J-1939 CAN2 ENGINE SUBNET CABLE OVERLAY INSTALLATION

Prevost vehicles

Model	VIN										
NYCT X3-45 Commuter coaches Model Year : 2012	 From 2PCG33495CC73<u>5053</u> up to 2PCG33495CC73<u>5232</u> incl. Except the following vehicles:

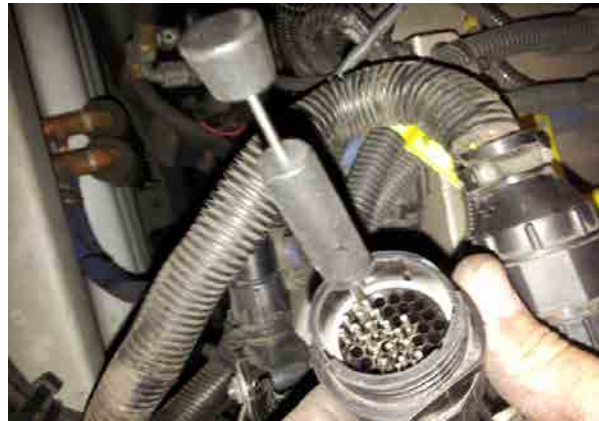
- 6) Disassemble connector C26.

- 7) Remove CAN H and CAN L terminal pins and wires from cavities 21 & 22. Install terminals on new wires, to do so, strip the wires, crimp on terminals 562275 (2x) and twist wires before inserting terminal pins in the connector plug.

- 8) Install new overlay cable harness CAN H and CAN L wire pins into cavities 21 and 22.

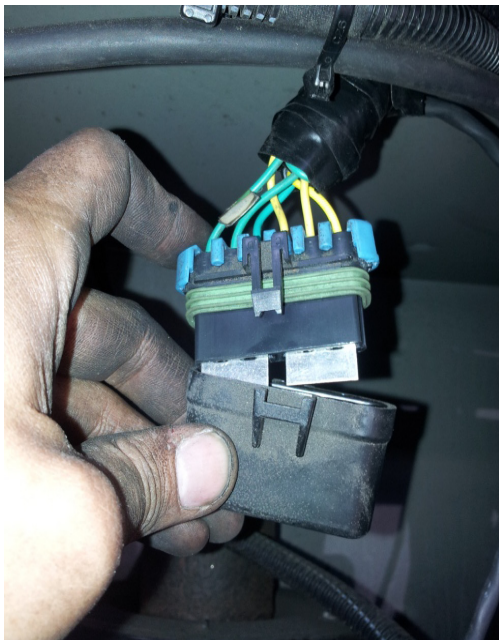
- 10) Disassemble S-Bar 1 connector and remove CAN H and CAN L wire pins from cavities A and D.

Strip the wires, crimp on terminals 564136 and twist wires before inserting terminal pins in the connector plug.

- 11) Install new overlay cable harness CAN H and CAN L wire pins into cavities A and D.
